## ADVISORY PLAN COMMISSION STAFF REPORT

Application No: 2021-APC-04

Subject: Proposed Zoning Map Amendment (Rezone) from the Agriculture (A) District to the Planned Unit Development (PUD) District, PUD Ordinance & Concept Plan Approval

CONCEPT PLAN

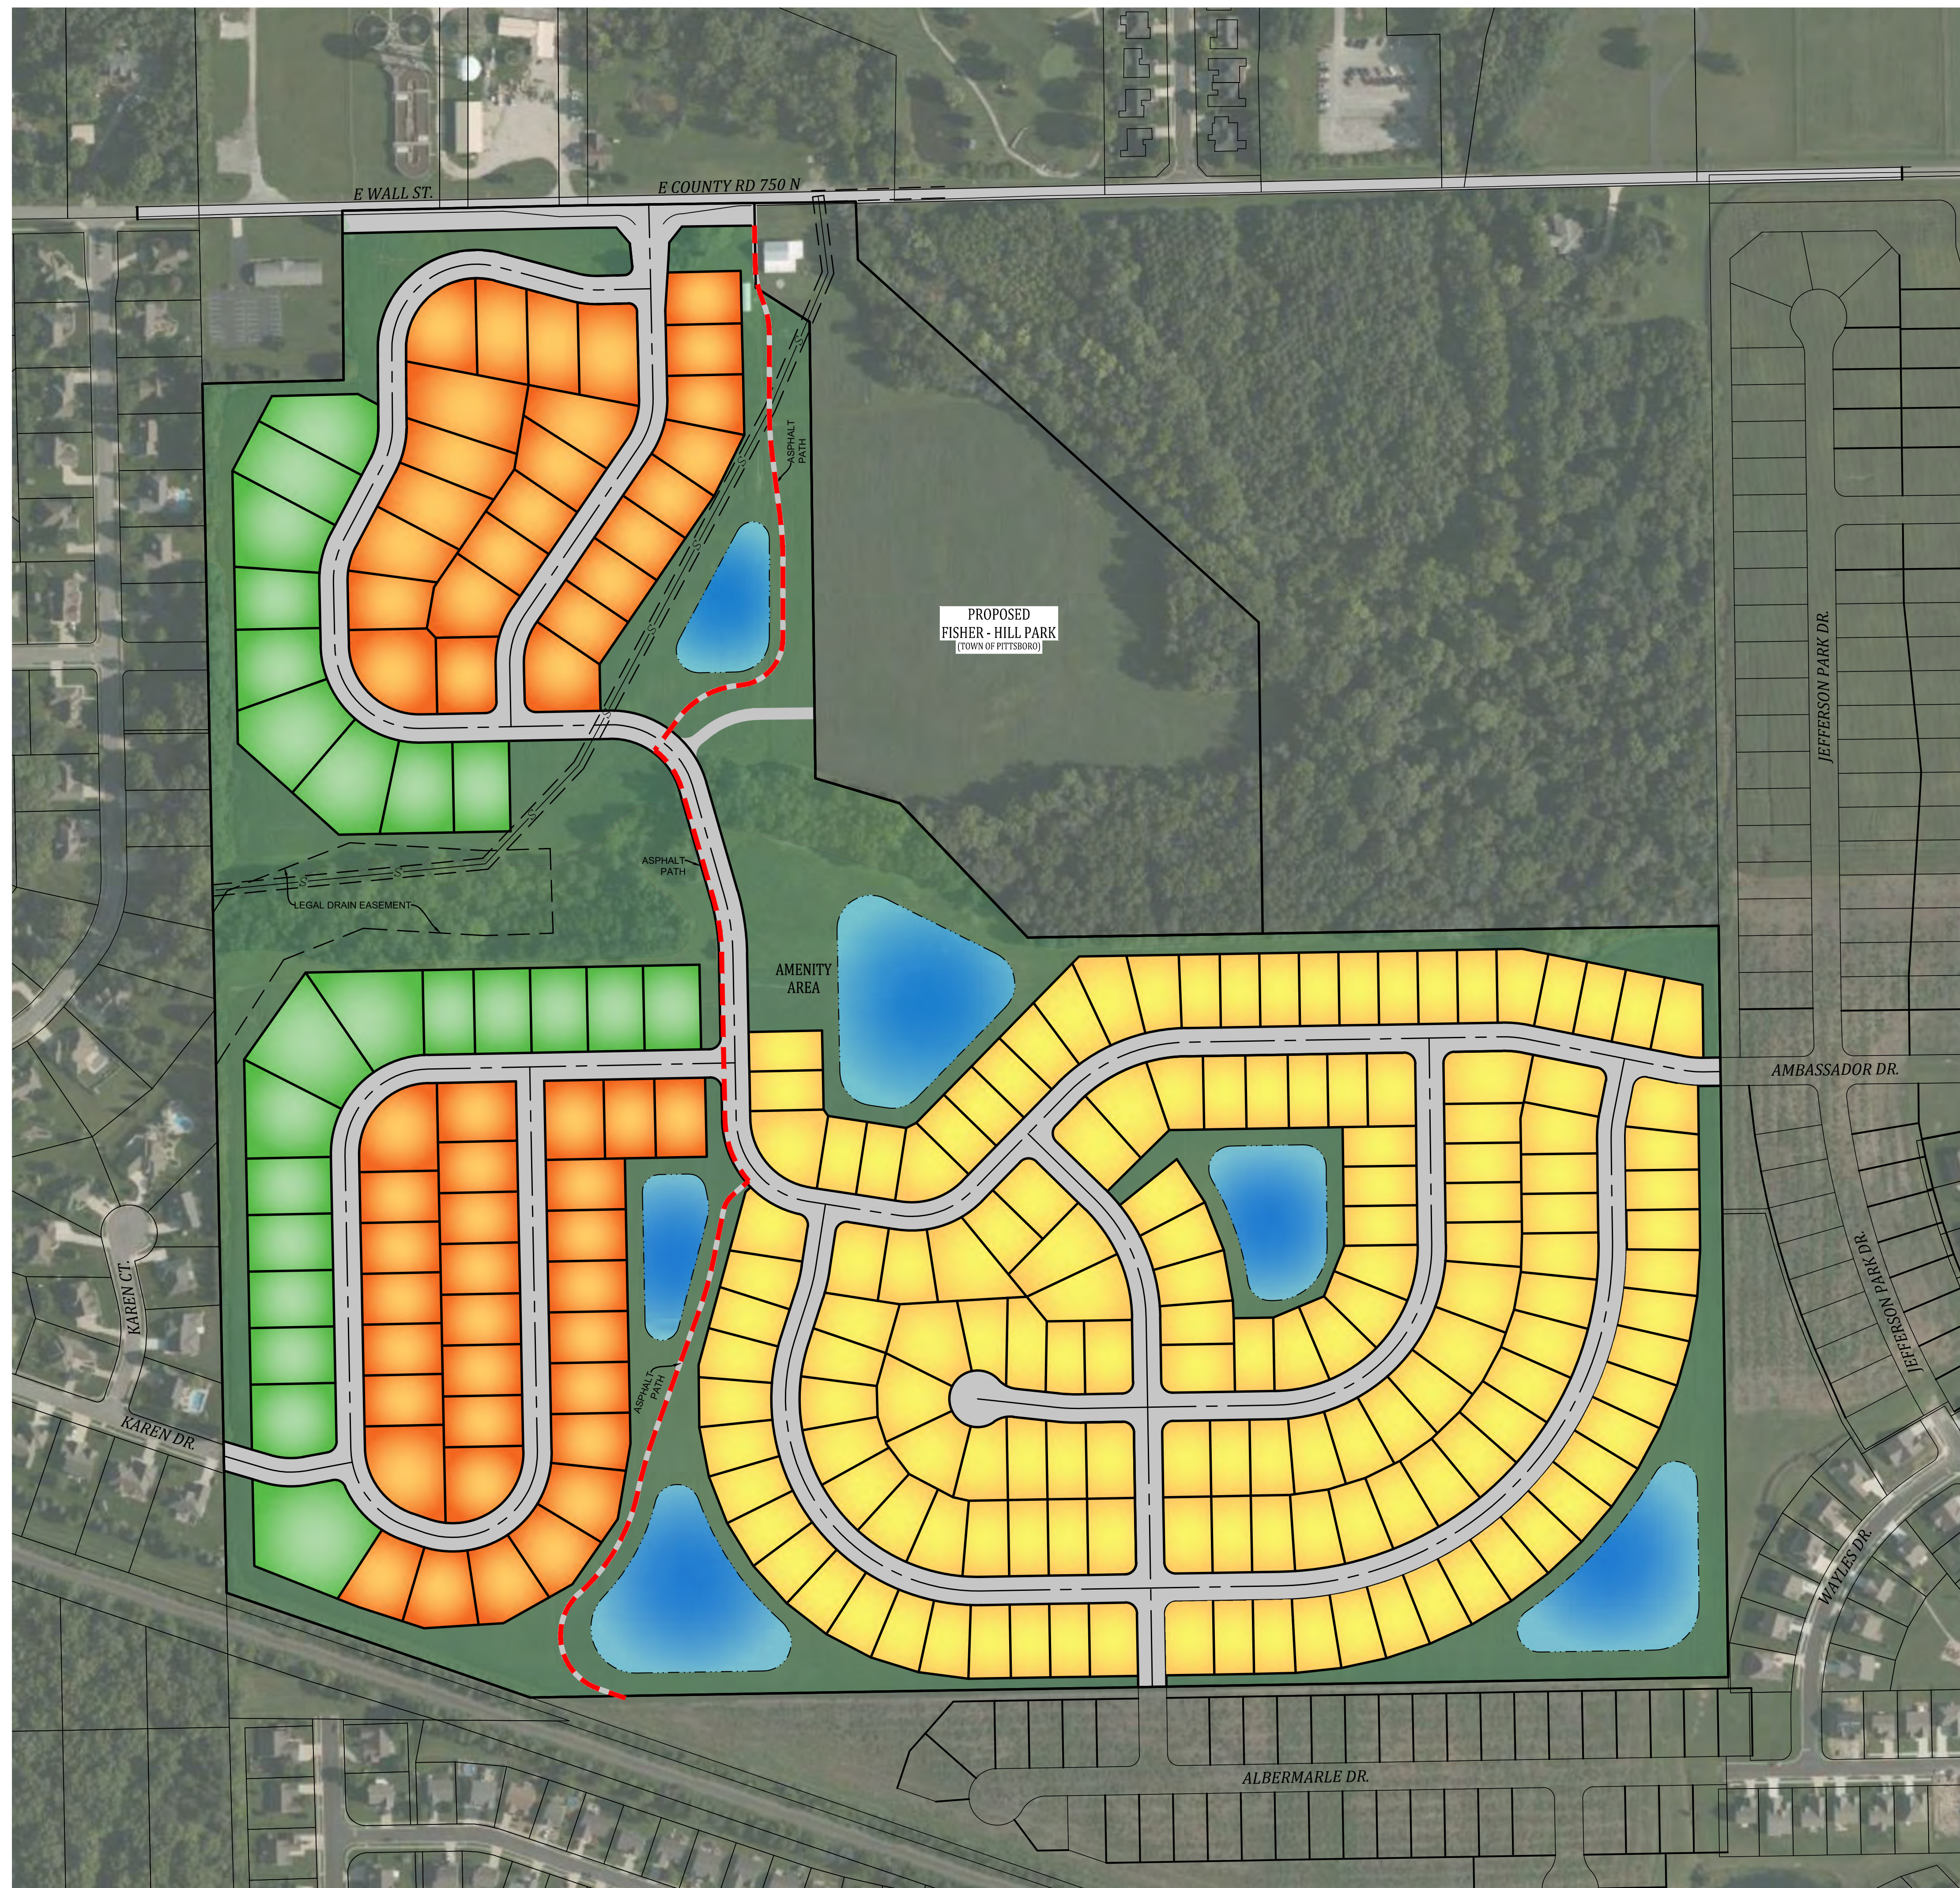
- The first three lots off Wall Street are to be removed and replaced with landscaping
    - Adam Peaper – I assume this is additional protection against odor complaints. I would think the above sub-bullet would address that.

- The large mature trees at the entrance and any other mature trees will not be removed without approval from the Town.
  - Show all amenities and types on the plan.

- Cameras to be installed at all amenity areas.
  - Solar flashing light at trail crossings.
  - Barn common area land to be changed to be park area land.

- The first three lots off Wall Street. *We have revised the layout to remove the lots that back up to Wall Street across from the treatment plant. We were able to reconfigure the concept slightly in order to not decrease the total number of lots in the community. Further, we agree to work with staff to increase the landscaping along our frontage of Wall Street across from the treatment plant.*

- Mature trees at the entrance. *We agree to work with staff to identify trees that we can save along Wall Street near our entrance.*
  - Show all amenities. *We have stated the likely amenities we intend to install. Based upon other comments regarding staff's desire for the developer to install amenities in the town park area, we believe that further discussion is necessary to discuss what amenities will go where.*

- Solar flashing lights. *We agree to install solar flashing lights at the trail crossing the streets. This has been added to the PUD Ordinance.*
  - Barn common area. *The revised concept plan shows the existing location of the barn to be in the area dedicated as town park.*
